SERVICE No. 1174 BULLETIN

Date: February 15, 2007

**LOCK ASSEMBLY- CABIN ENTRANCE DOOR,
FORWARD BAGGAGE DOOR, AFT BAGGAGE
DOOR, and NACELLE LOCKER DOOR**

**Figure 1
(Correct Length)**

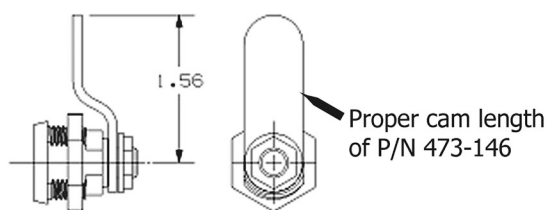
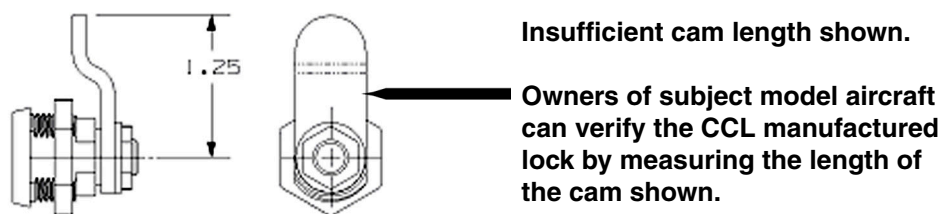
It has been discovered that between March 2006 and May 2006 the Piper factory shipped lock assembly P/N 473-146, which may not meet the drawing specifications for cam length. Piper drawing 25163-003 requires the cam to measure 1.56 inches from the center of the lock to the tip of the cam (See Figure 1).

The lock assemblies shipped between March 2006 and May 2006 (manufactured by CCL Security Products under the Piper code number 473-146) have a reduced cam length. The measurements of these cams are 1.25 inches from the center of the lock to the tip of the cam (See Figure 2).

Left uncorrected, the shortened cam could result in locking mechanism failure or a latching failure, allowing the door to be opened.

1. At all applicable locations where Piper Lock Assembly P/N 473-146 is required, perform the inspection described in this Service Bulletin. If the cam length from axis of rotation to end of cam is 1.56 inches at all locations, proceed to Step 3. If any cam does not measure at least 1.56 inches, proceed to Step 2.

2. For each 473-146 lock assembly that does not meet the 1.56 inch dimensional requirement, order and install Lock Modification Cam Lock Replacement Kit, Piper Part Number 88406-002
3. Make a log book entry indicating compliance with Step1 and/or Step 2, as applicable.
